**DEFENSE NUCLEAR FACILITIES  
SAFETY BOARD**

## Staff Report

August 16, 2019

### Safety Basis for the Plutonium Facility at Los Alamos National Laboratory

**Figure B-1.** ICRP-71 Annexe D.2 Recommended Assignments against Park’s Data

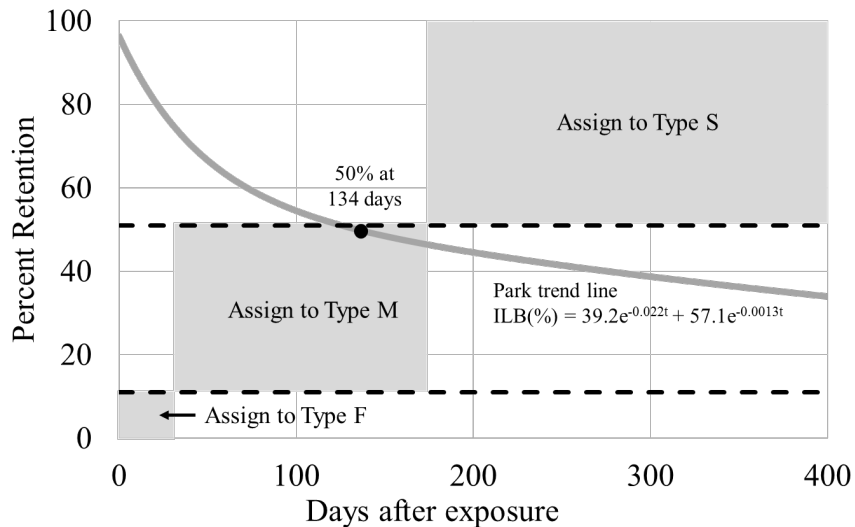
Annexe D of ICRP-71 provides guidance for assigning lung clearance types to radionuclides based on experimental data. Figure D.2 in ICRP-71 establishes regions for assigning lung clearance types to experimental data of lung retention behavior. Figure B-1 below overlays Park’s fit of the experimental data (initial lung burden [ILB]) with Figure D.2 of

ICRP-71. The resulting figure with the corresponding trend line demonstrates that 50 percent lung retention occurs at 134 days, which the ICRP guidance indicates is consistent with Type M material.

The staff team is also concerned that LANL has not provided a technical basis for the application of the intermediate dose conversion factor to other forms of HS-Pu including oxalates, non-fired granules, and hydroxide cakes. ICRP does not provide guidance for  $^{238}\text{Pu}$  in these forms nor does it relate their solubility characteristics to  $^{238}\text{Pu}$  oxides. Without a firm technical basis, the staff team believes that LANL should be using ICRP’s recommended default of Type M.
